EPC STORMWATER REVIEW COMMENTS IN ORANGE BOXES WITH BLACK TEXT

OVERALL ALTERNATIVE LANDSCAPE PLAN

The Shire At Old Ranch
Howells & Old Ranch Road
Colorado Springs, CO

LS 1

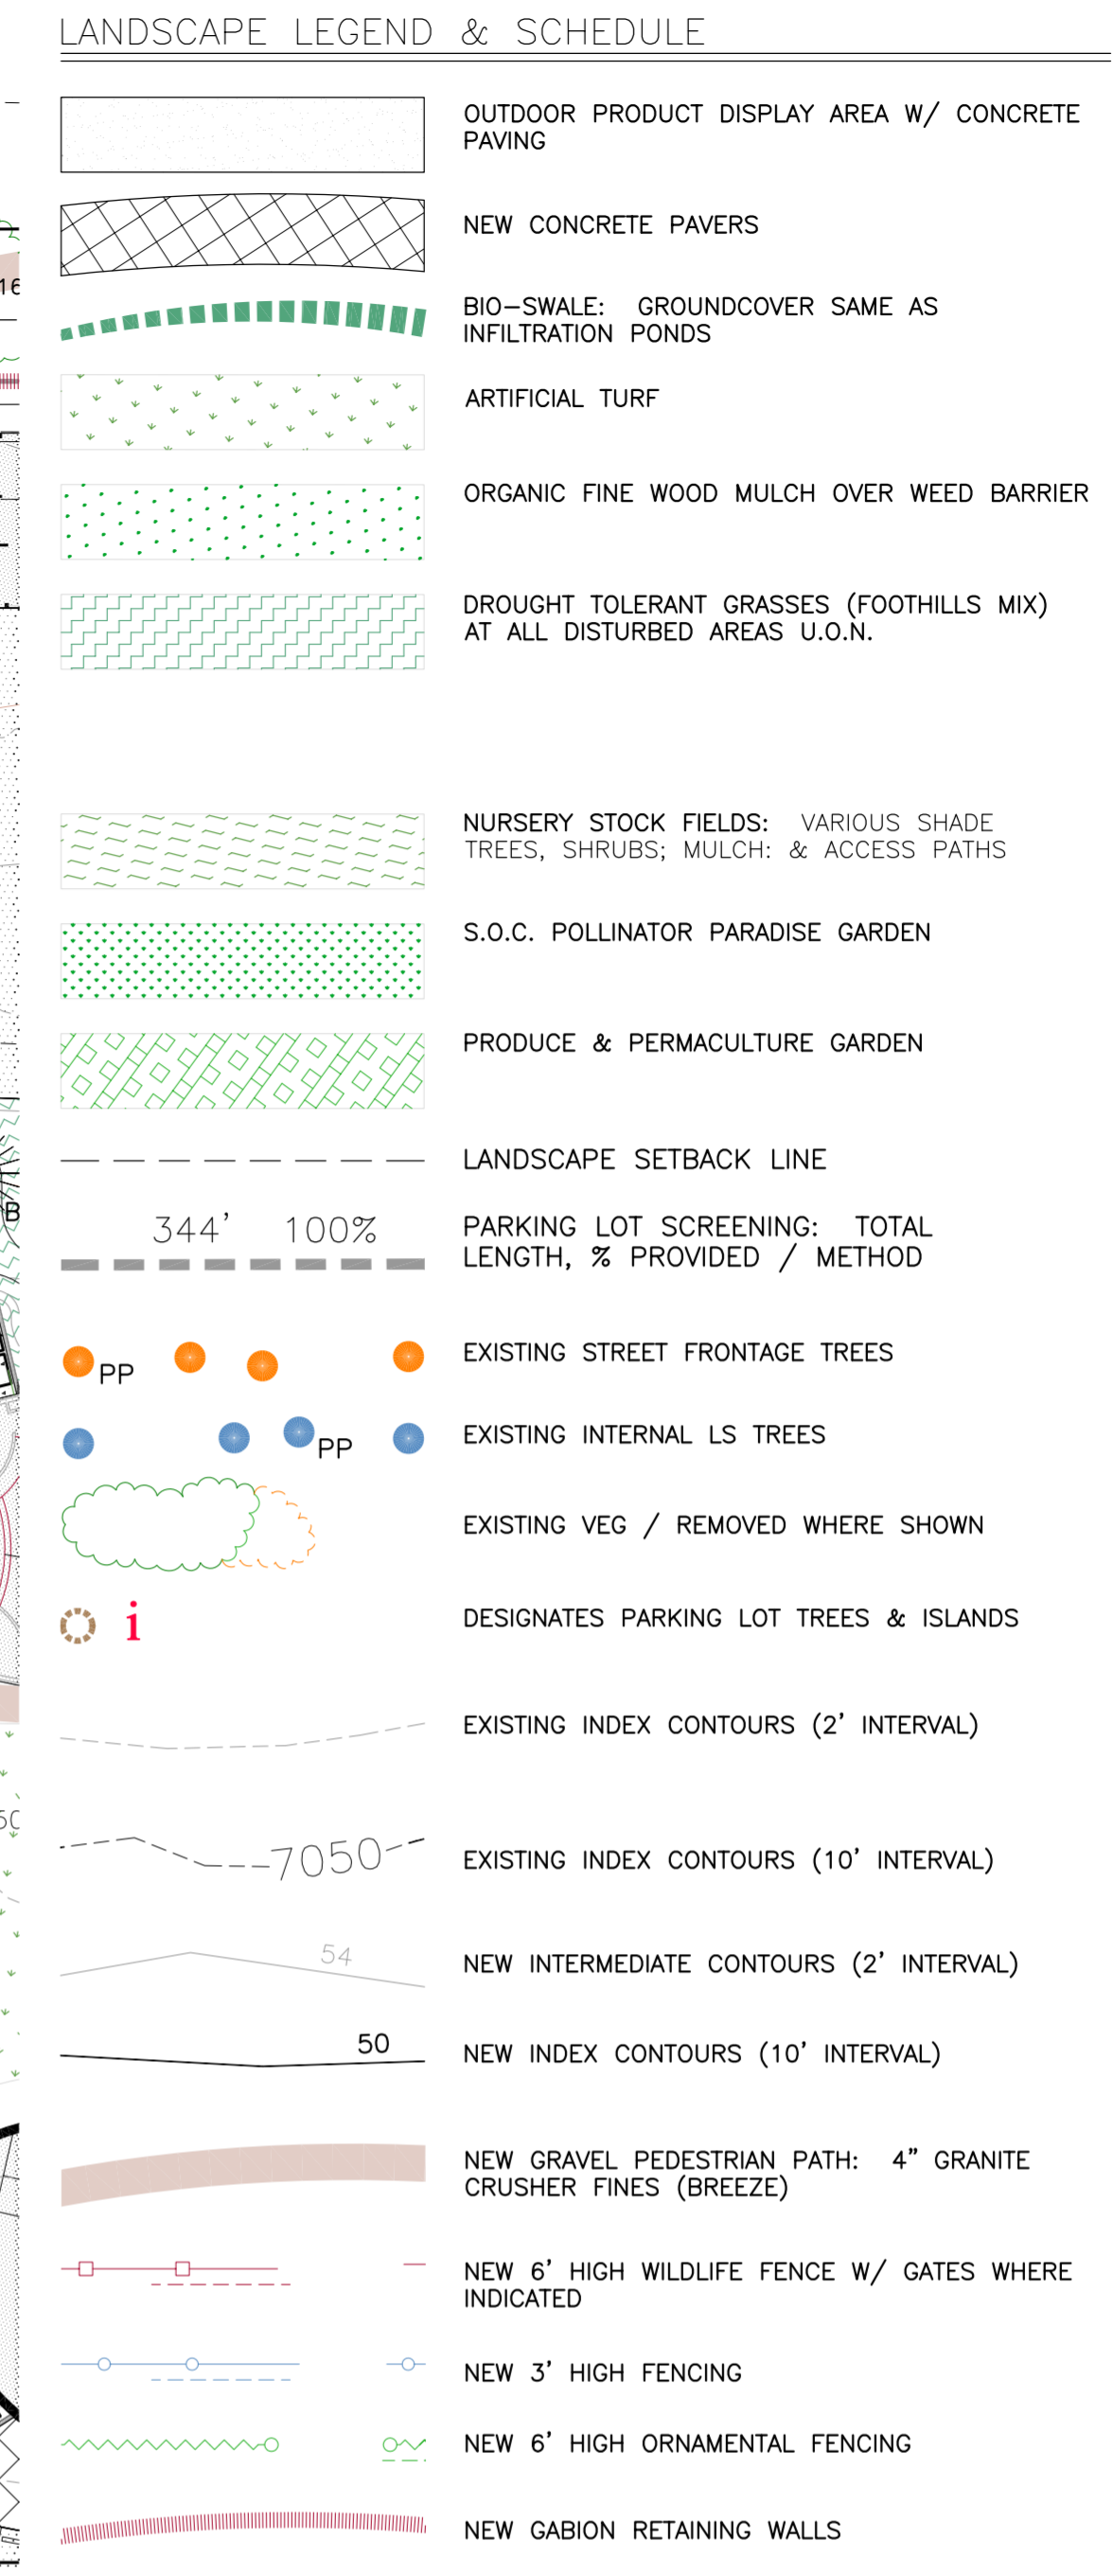
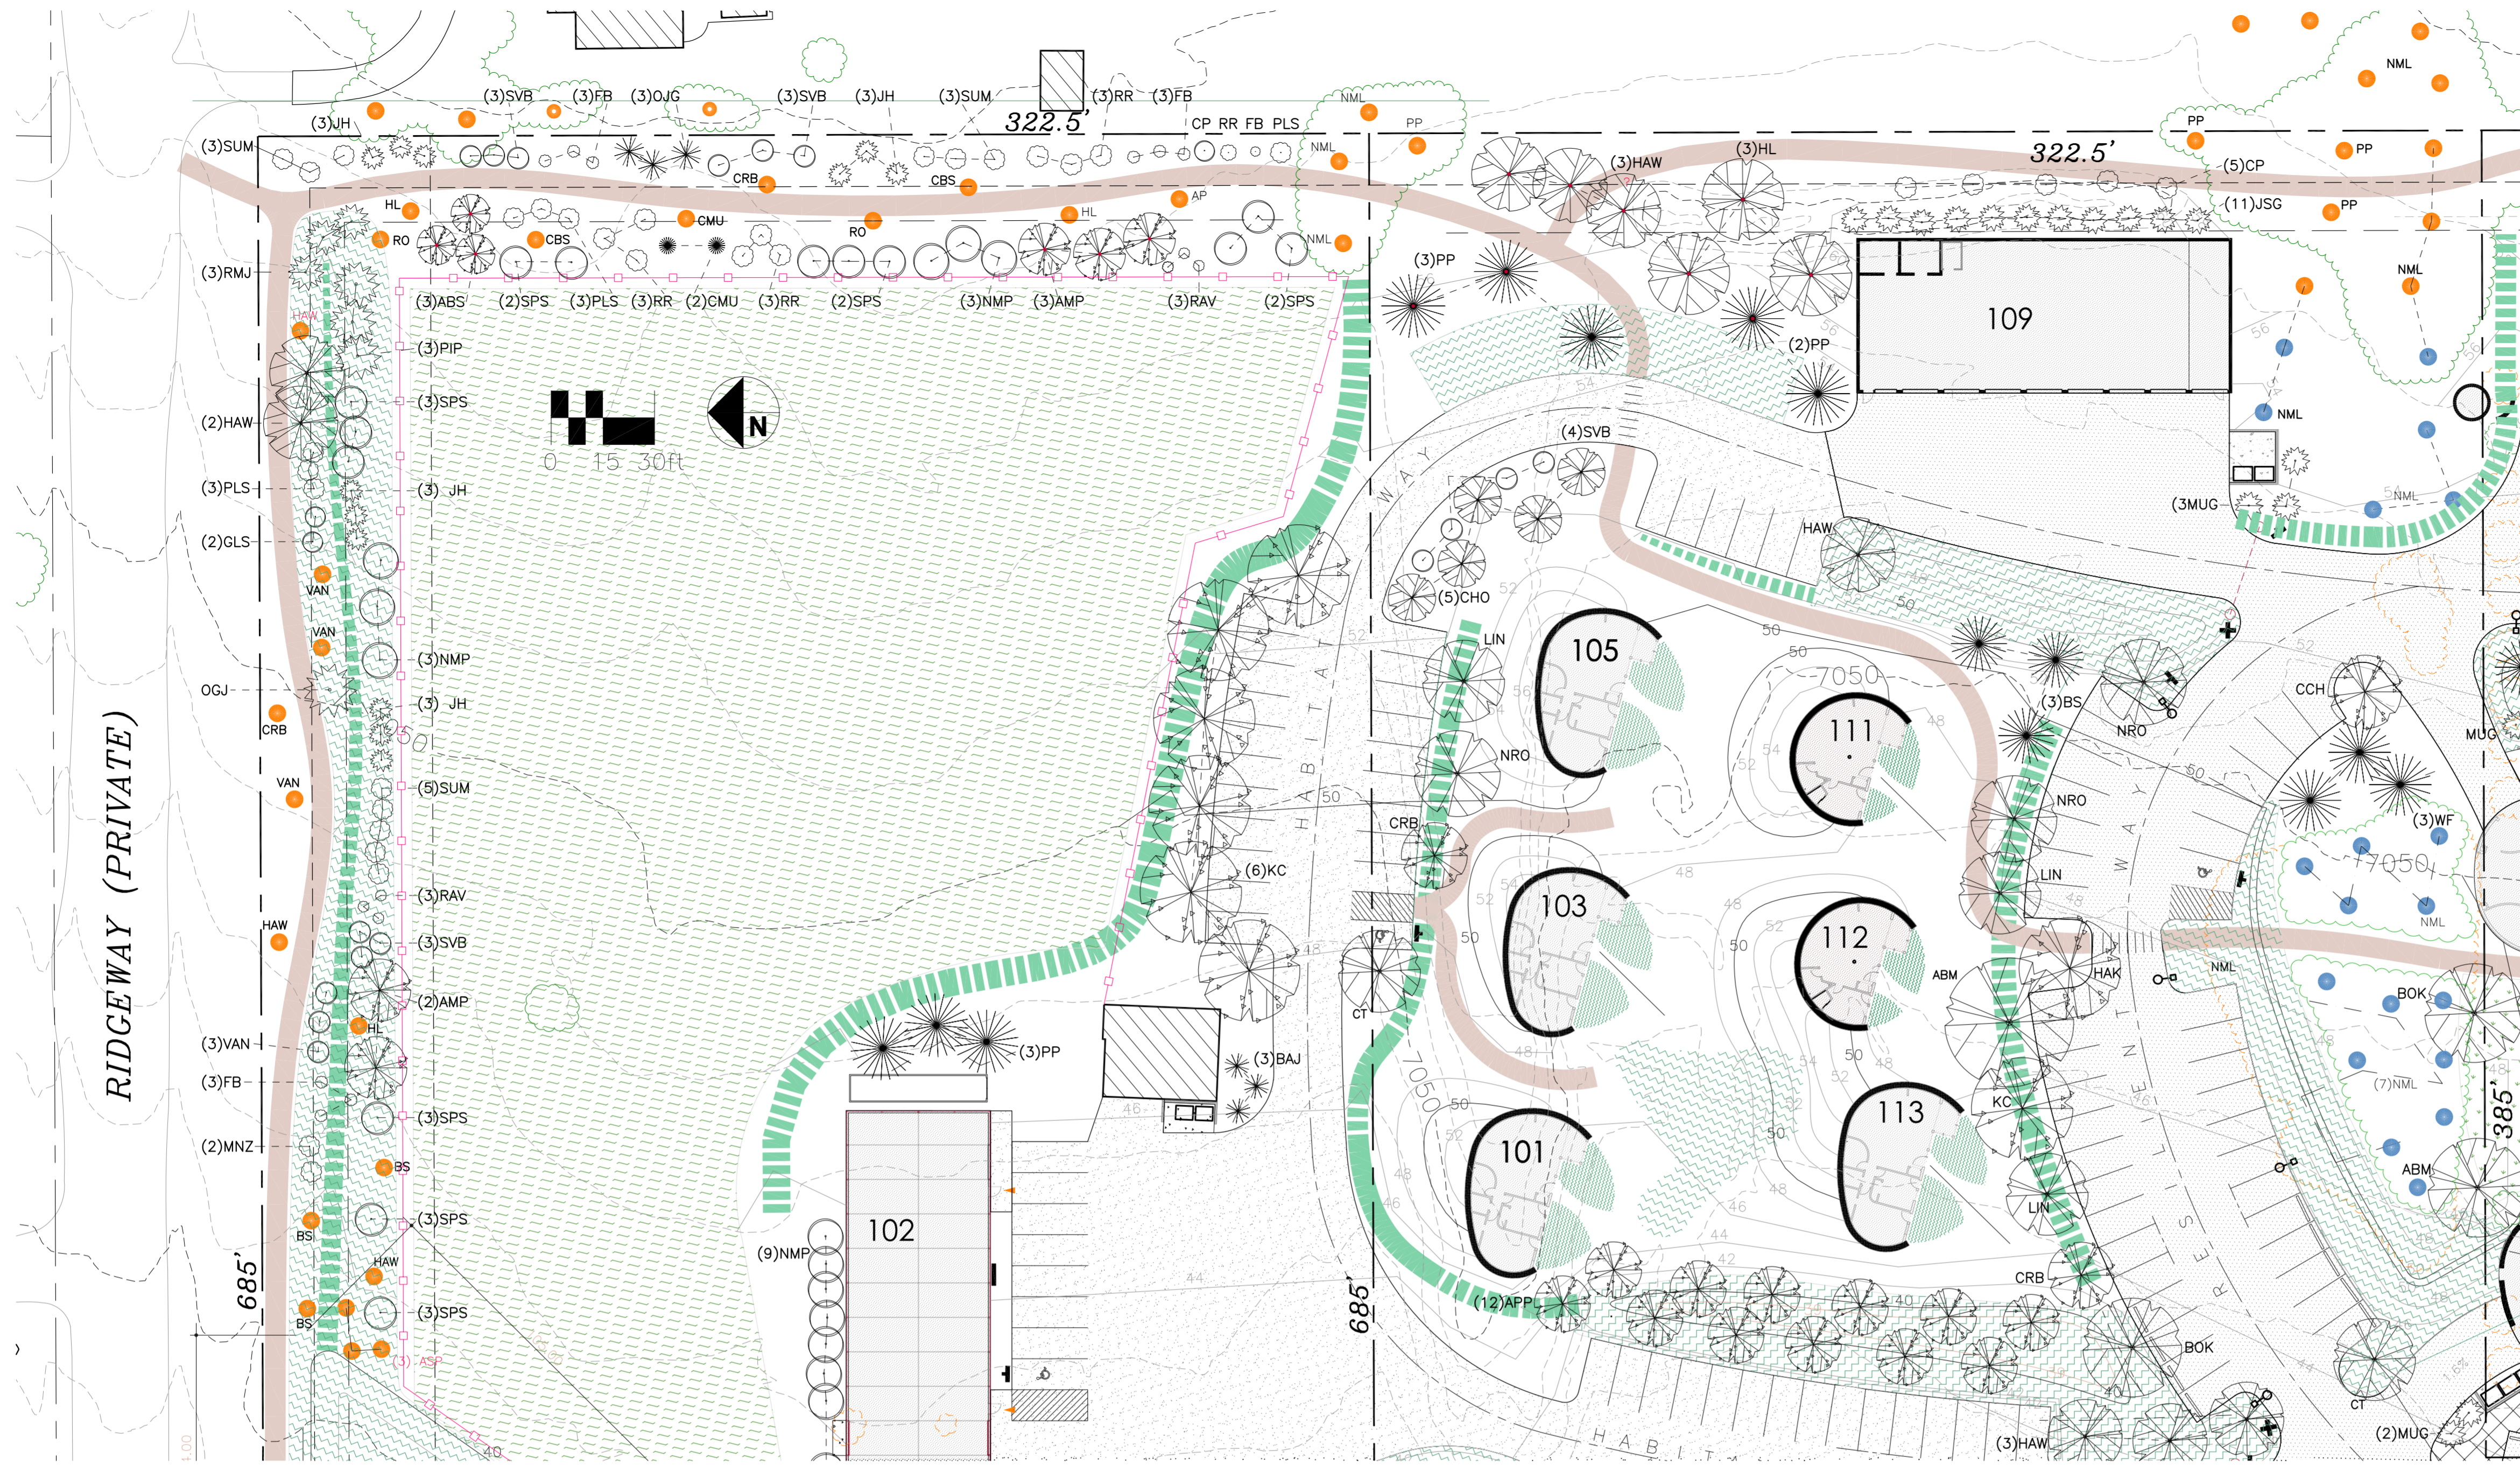
PLEASE INCLUDE:

- any loading or garbage dumpsters near landscaping
- any easements

- Property address
- Property tax schedule number
- Current zoning of the property
- Lot/parcel size

The existing zoning of the subject property and the existing zoning of surrounding properties.

please provide size of islands, per the new code update for landscaping they should be 9 x 18 ft or equivalent of 2 parking spaces

Please depict where all islands are as they relate to this project

These are the same please revise

Please consider using colors that are easier to see on plans such as, red, dark blue, dark purple, bright pink

Please include: File Number: PPR2410
